INDESIT company

Model type:
IDL55SIT.2

Commercial code:
F034120

N1045072FIG1

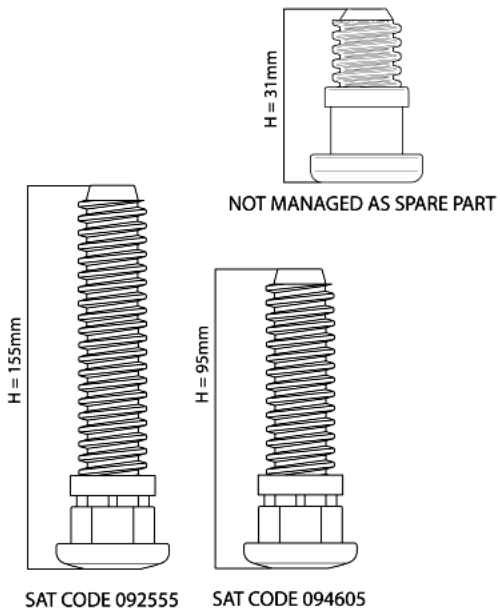
N1045072: Introduction of fixed rear foot H=31mm on free-standing models.

From serial no. 40218.0001, free-standing dishwashers affected by this modification have been equipped with new fixed rear feet (H=31mm).
The new foot replaces the adjustable one (H=155mm) Service code 092555; on the EVO3 range with TurboDry the new foot replaces the adjustable foot (H=95mm) Service code 094605.
The Spare Part Warehouse will continue to manage only 155mm and 95mm adjustable feet as they are interchangeable with the fixed 31mm foot.
The three feet are shown in illustration N1045072FIG1.

N1045133/134FIG1

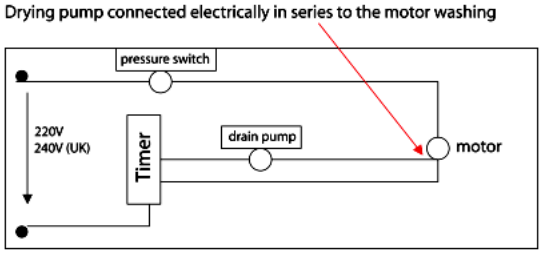
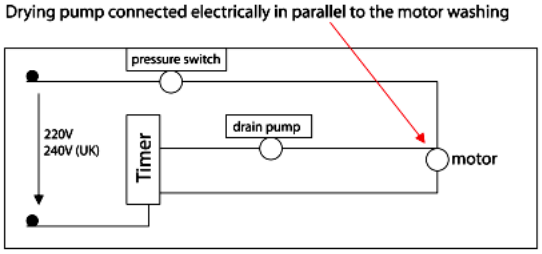
n1045133: New thermoprotected drain pump in parallel with wash electric pump

The drain pump electrical connection has been modified from a configuration in series with the wash electric pump to one in parallel.

The drain pump in series with the wash electric pump is fed through the wash electric pump causing a voltage drop equal to -15V (diagram N1045133-134FIG1).

The drain pump in series with the wash electric pump is electrically fed directly by the F-N line, without any voltage drop (diagram N1045133-134FIG1).

New parts:
Wiring in parallel
C00118767(Rohs 143766) - thermoprotected drain pump 220/240V 50HZ 26W - picture (N1045133-134FIG3)

Premodification parts:
Wiring in series
C00112306(Rohs 143739) - drain pump 230V 50HZ 22W - picture (N1045133-134FIG4)

Important!!
The thermoprotected drain pump cannot be installed on premodification dishwashers.
The non-thermoprotected drain pump cannot be installed on modified dishwashers.

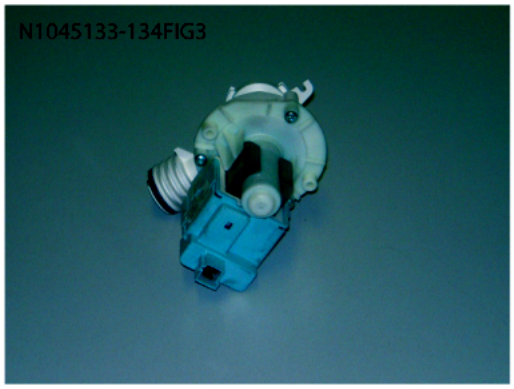
n1045135: New single-pole On/Off switch

The two-pole On/Off switch has been replaced by the single-pole switch.

New parts
Wiring
C00140609 - single-pole On/Off switch

C00063971 - single-pole On/Off switch
C00140607 - single-pole On/Off switch

Premodification parts
Wiring
C00041184 - two-pole On/Off switch
C00058465 - two-pole On/Off switch
C00096884 - two-pole On/Off switch

N1045136FIG1

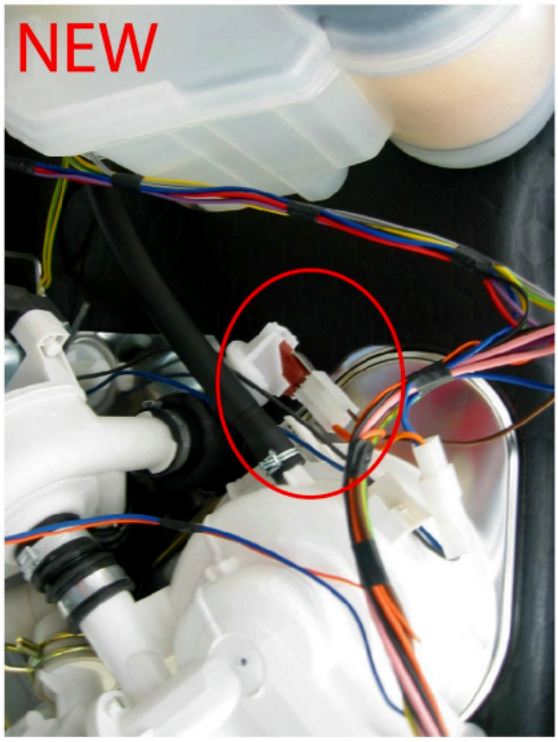
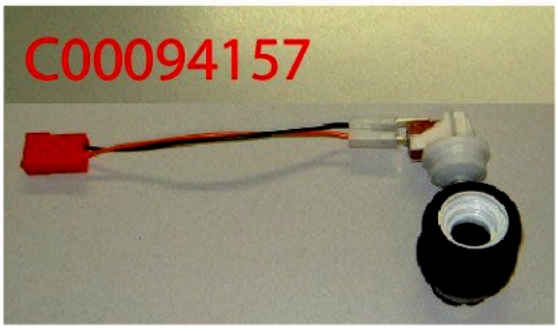
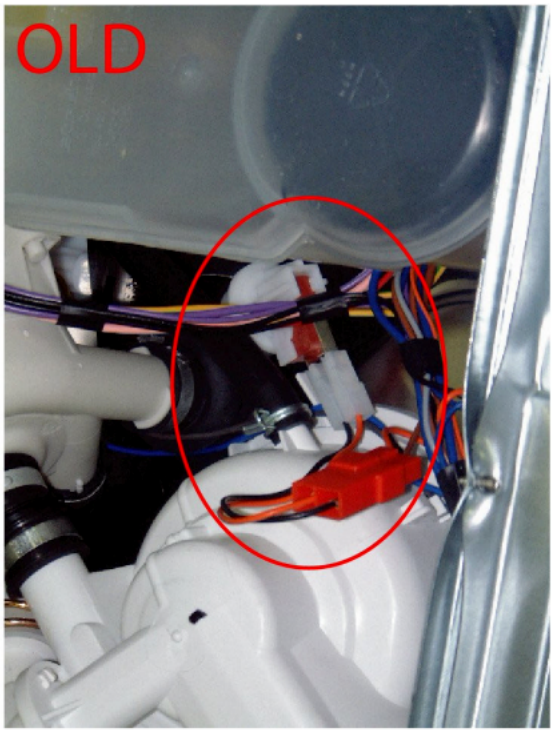
n1045136: introduction of new high pressure sensor

In modified products the connector going to the high pressure sensor is part of the wiring assembly (see picture N1045136FIG1). In premodification products the high pressure sensor is connected to the wiring assembly by a cable that is part of code C00094157 (see pictures N1045136FIG2-3).

New parts
Wiring
C00142435 - high pressure sensor

Premodification parts
Wiring
C00094157 - high pressure sensor + cable

The new parts are not individually interchangeable with premodification ones.
